The Commission has issued the enclosed Amendments Nos. 45 and 45 to Facility Operating Licenses Nos. DPR-44 and DPR-56 for the Peach Bottom Atomic Power Station Units Nos. 2 and 3. The amendments revise the Technical Specifications in response to your request of July 16, 1976, as supplemented April 18 and August 29, 1977, March 27 and April 26, 1978.

These amendments revise the Technical Specifications to modify the reactor coolant system thermal and pressurization limitations to account for neutron irradiation induced increases in reactor vessel metal nil ductility temperature.

PEACH BOTTOM ATOMIC POWER STATION, UNIT NO. 2

AMENDMENT TO FACILITY OPERATING LICENSE

Figure 3.6.3

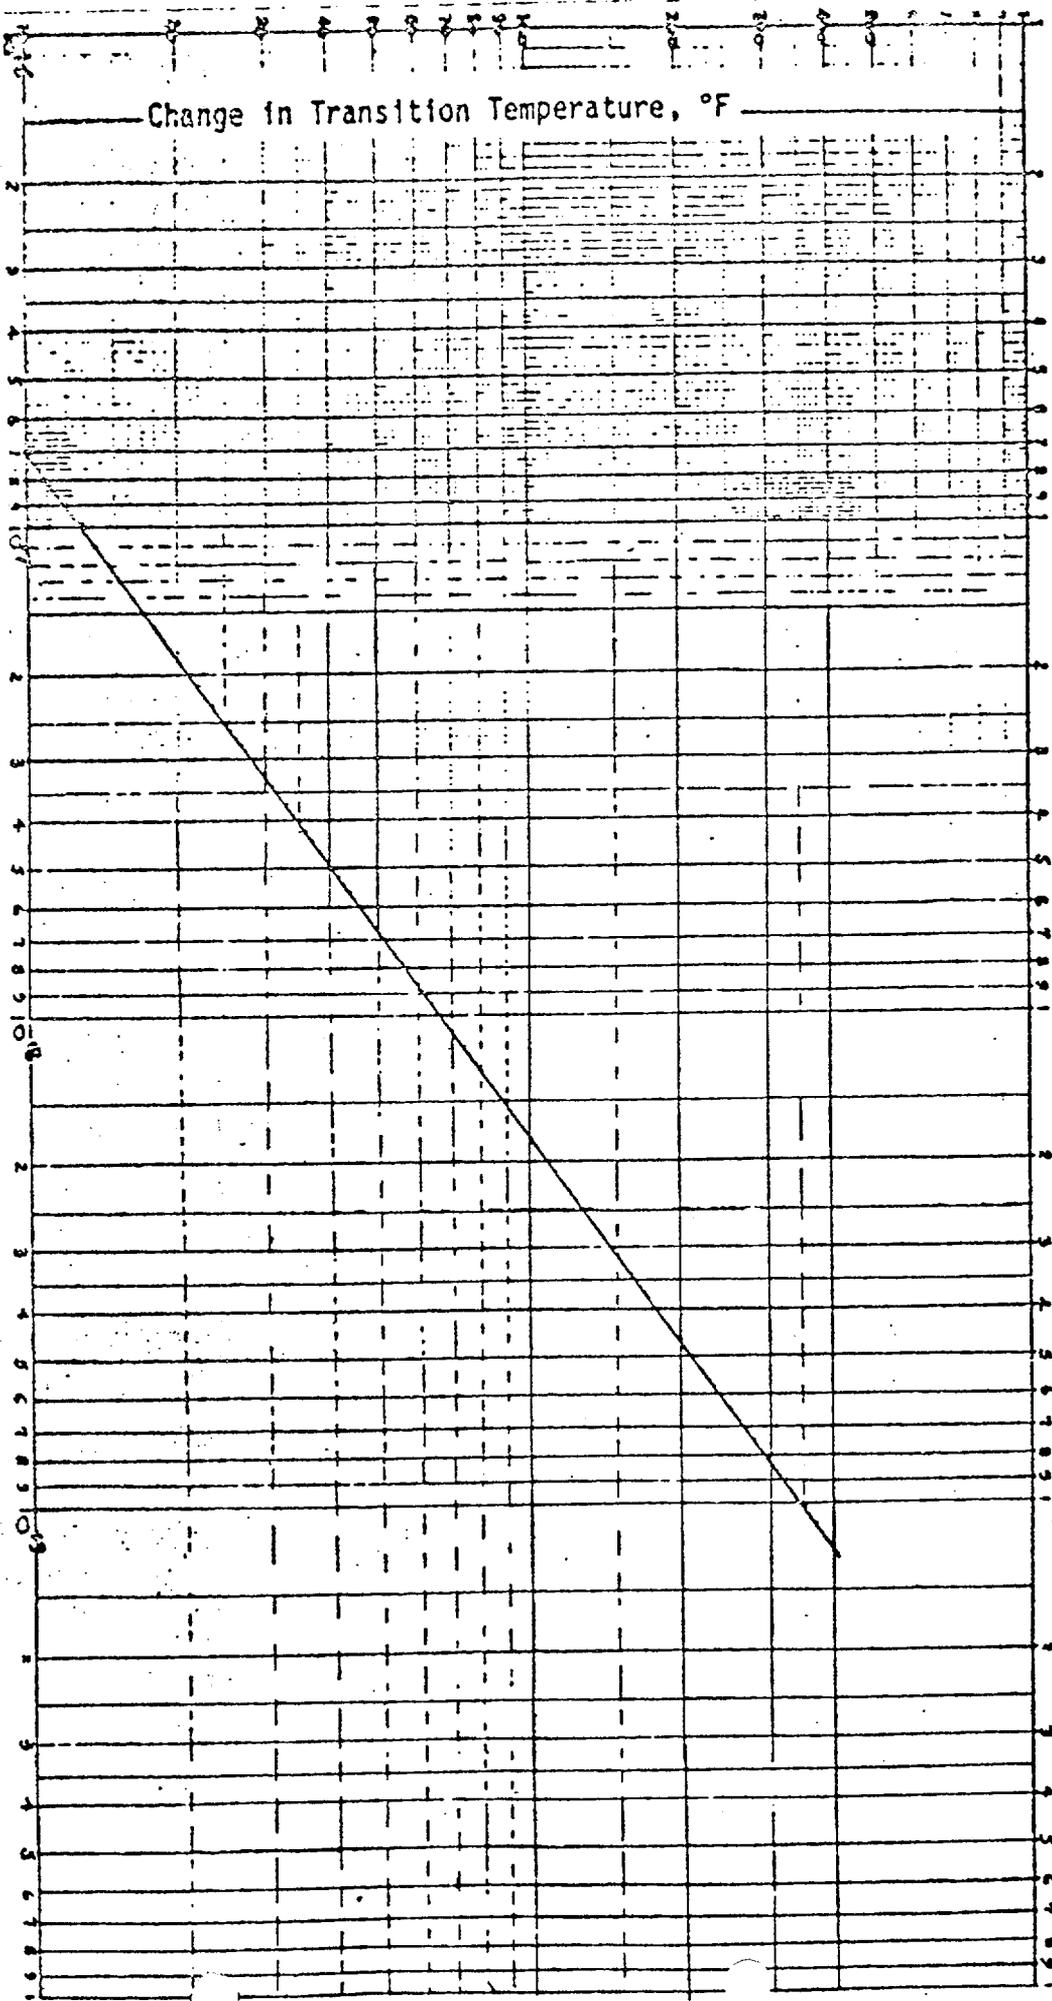
The reactor vessel shall not be pressurized during operation with a critical core above the pressure allowable by Figure 3.6.3, based on the temperatures recorded under 4.6.A.

The vessel pressurization temperatures at any time period can be determined from the thermal power output of the plant and its relation to the neutron fluence and from Figure 3.6.1, 3.6.2, or 3.6.3 in conjunction with Figure 3.6.4. Note: Figure 3.6.3 includes an additional 40°F margin required by 10 CFR 50 Appendix G.
